When the leaves are down on Church Hill Woods

To the Planning Board from Joshua Meyrowitz, May 25, 2021

Thank you for agreeing to start at Chesley Drive for the Wednesday, May 26, 2021, Site Walk for the Church Hill Woods proposed parking structure.

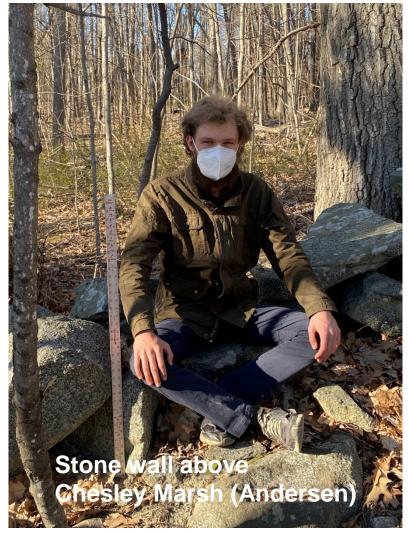
Even at most solid parts, old wall only about 3 ft high.

And <u>land rises sharply behind</u> <u>old wall</u>, which would make 20? ft proposed parking mound fully visible.

In other sections, old wall barely rises above ground.

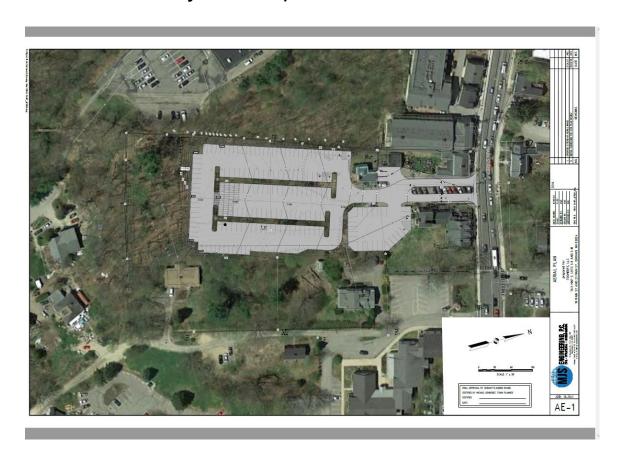
As I critiqued at the May 12, 2021, Public Hearing, "flat-as-a-pancake" images (such as the one sent by Mike Sievert to the Planning Board on May 24, 2021, below) distort what the mass structure proposed would look like from abutting properties, from the Chesley Marsh, and from the College Brook bridge so popular with the entire neighborhood. The topography so cherished on Church Hill, as a HILL, is not yet displayed as it would be transformed by such a plan. That's essential evaluative material.
